Amendments to the Drawings:

Remarks/Arguments

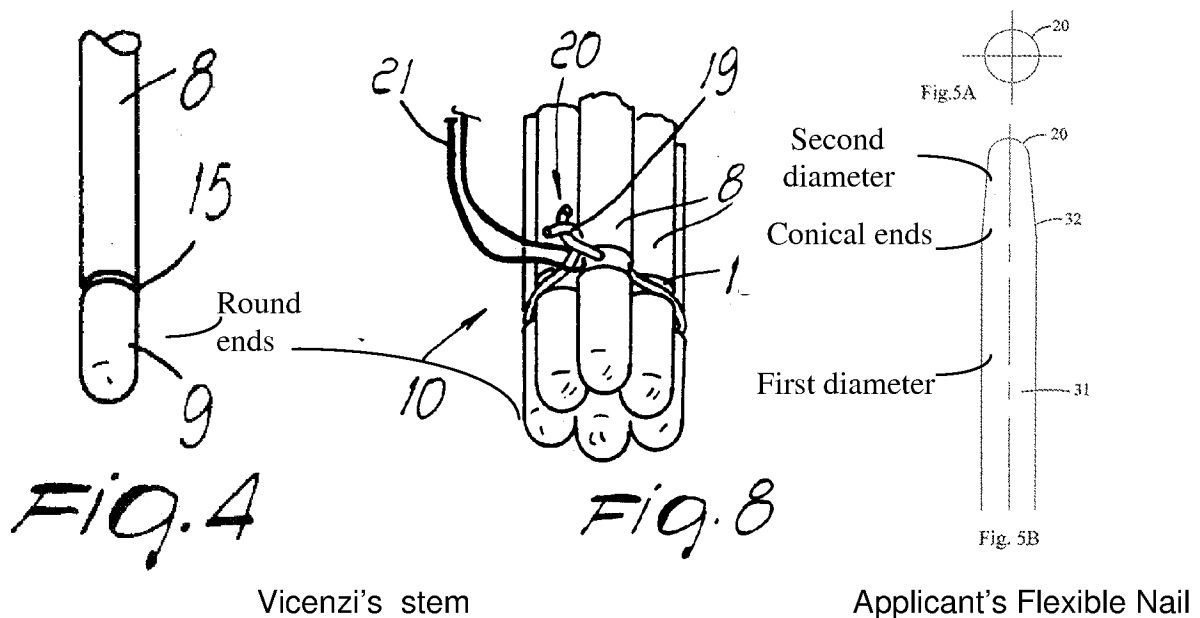
Applicant respectfully disagree with argument of examiner on page no.16-17 of Final Office Action that applicant's same universal length flexible nail can't be used in realistic condition in two different size patient (baby and 6 feet tall man). Applicant respectfully argues that applicant's flexible nail of universal length (for example 50 cm) is free at a first end and also free at a second end and it is not bundled at one end, user (surgeon) is allowed after final insertion to cut nail to size (in fraction of millimeter or centimeter) of bone of a baby or tall man keeping 1 cm out protruding from an entry in a bone. When a surgeon takes a person for surgery of fixing a bone with flexible nail having curvatures in particular can't decide exact and effective length (i.e. extending across the fracture zone, not penetrating inner wall of bone or growth plate at leading end and not irritating soft tissue at non leading end) of nail to be used before hand , so Applicant claims nail of universal length (for example 50 cm) which allows surgeon to *effectively extend* nail across fracture zone ,after conforming final insertion and placement of leading end to desired position, surgeon will cut non leading end keeping 1cm out protruding - *not irritating soft tissue* at non leading end. Applicant respectfully argues that flexible nail as claimed by applicant will require to have universal length for all sizes of bones reducing inventory and allowing surgeon to have *effective and exact length* of nail for a particular patient and bone. As disclosed and taught by Vicenzi and from above facts applicant respectfully argues that Vicenzi's Pin 1 is no longer in position to meet limitation of universal length and it does not read on claim 13.

2. Structure of Vicenzi Pin 1 requires **at least two** stems 8 for operation of said Pin 1 (Col 2 lines 37-38 , Col 4 Claim 1 lines 24-25 ,), while applicant discloses and claims in claim 13 an orthopedic implant flexible intramedullary nail comprising **a single** flexible nail of universal length. Applicant's implant flexible intramedullary nail can operate having structurally a single flexible nail of universal length having a plurality of curvatures at a plurality of planes, while to operate Vicenzi's Pin 1 it requires to have structure of at least two stems 8 in intramedullary Pin 1 to fix a fracture in a bone. So structurally Vicenzi's Pin 1 is different than applicant's implant flexible intramedullary nail.
3. Structure of Vicenzi's Pin 1 requires stem 8 at one end to be rigidly associated or connected with proximal stub 2, while Applicant discloses and claims structure of

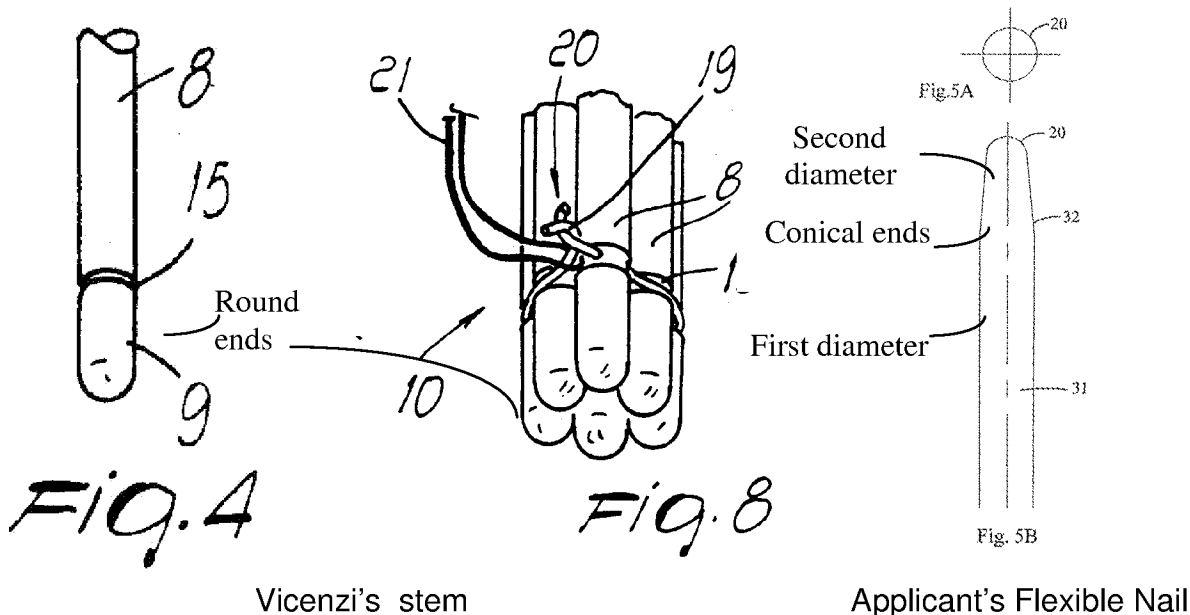
Applicant respectfully argues that applicant's flexible nail of universal length (for example 50 cm) is free at a first end and also free at a second end and it is not bundled at one end, user (surgeon) is allowed after final insertion to cut nail to size (in fraction of millimeter or centimeter) of bone of a baby or tall man keeping 1 cm out protruding from an entry in a bone. When a surgeon takes a person for surgery of fixing a bone with flexible nail having curvatures in particular can't decide exact and effective length (i.e. extending across the fracture zone, not penetrating inner wall of bone or growth plate at leading end and not irritating soft tissue at non leading end) of nail to be used before hand, so Applicants claims nail of universal length (for example 50 cm) which allows surgeon to effectively extend nail across fracture zone, after conforming final insertion and placement of leading end to desired position, surgeon will cut non leading end keeping 1cm out protruding - not irritating soft tissue at non leading end. Applicant respectfully argues that flexible nail as claimed by applicant will require to have universal length for all sizes of bones reducing inventory and allowing surgeon to have effective and exact length of nail for a particular patient and bone. As disclosed and taught by Vicenzi and from above facts applicant respectfully argues that Vicenzi's Pin 1 is no longer in position to meet limitation of universal length.

2. Structure of Vicenzi's Pin 1 requires stem 8 at one end to be rigidly associated or connected with proximal stub 2, while Applicant discloses and claims structure of flexible nail where first and second ends are free without any attachment. So structurally Vicenzi's Pin 1 is different than applicant's implant flexible intramedullary nail.
